Access Compliance Report

Public Rights-of-Way

(Curb Ramps)

Intersection ID: 44308	Main Street: VALERIE_DR	Cross Street: OLIVIA_DIANE_LN	Location: NW
ADA ID: 0001649E1040	Ramp Type: PerpDiag	Initial Pass/Fail: Fail	Overall Compliance: No
Severity Score: 42.5			
Codes/Mitigation Info/Possible Solution		Field Measurements/Component Compliance

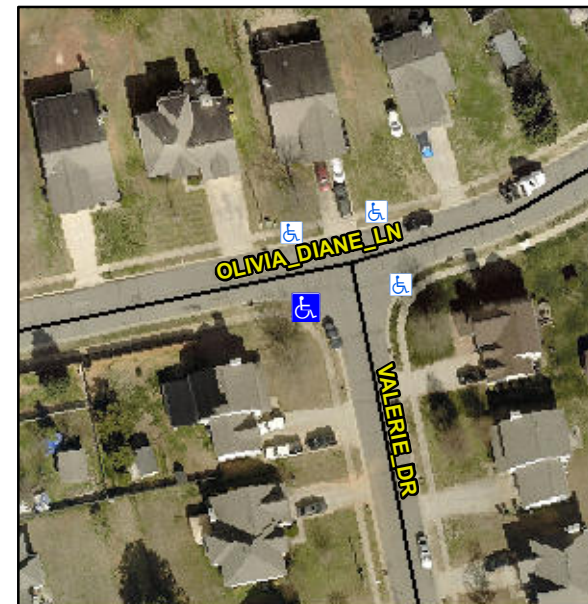
Not Found, R304.5.1, R304.5.3

Compliance	Description	Data	Compliance	Description	Data
N/A	Ramp Length (in)	95.5	Yes	Ramp Slope (%)	6.4
No	Ramp Width (in)	32.5	No	Ramp XSlope (%)	9.0
N/A	Flare Type LT	N/A	N/A	Flare Type RT	N/A
N/A	Flare Slope LT (%)	N/A	N/A	Flare Slope RT (%)	N/A
N/A	Flare Traversable LT?	N/A	N/A	Flare Traversable RT?	N/A
N/A	Landing Length (in)	N/A	N/A	DWS Provided?	N/A
N/A	Landing Width (in)	N/A	N/A	DWS Contrast?	N/A
N/A	Landing Slope (%)	N/A	N/A	DWS Length (in)	N/A
N/A	Landing X Slope (%)	N/A	N/A	DWS Full Width?	N/A
N/A	Landing Curb? (Y/N)	N/A	N/A	DWS Offset (in)	N/A
N/A	Shared Landing?	N/A			
N/A	Gutter Ponding?	N/A	N/A	Gutter Slope (%)	N/A
N/A	Gutter Lip Ht (in)	N/A	N/A	Gutter X Slope (%)	N/A
N/A	Painted X Walk1?	No	N/A	Painted X Walk2?	No
	X Walk 1 Direction	To E		X Walk 2 Direction	To N
N/A	X Walk 1 Width (in)	N/A	N/A	X Walk 2 Width (in)	N/A
	X Walk 1 Slope (%)	3.0		X Walk 2 Slope (%)	3.2
	X Walk 1 X Slope (%)	4.4		X Walk 2 X Slope (%)	5.9

Remove & Replace Curb Ramp With Two New Directional Ramps or Equivalent.
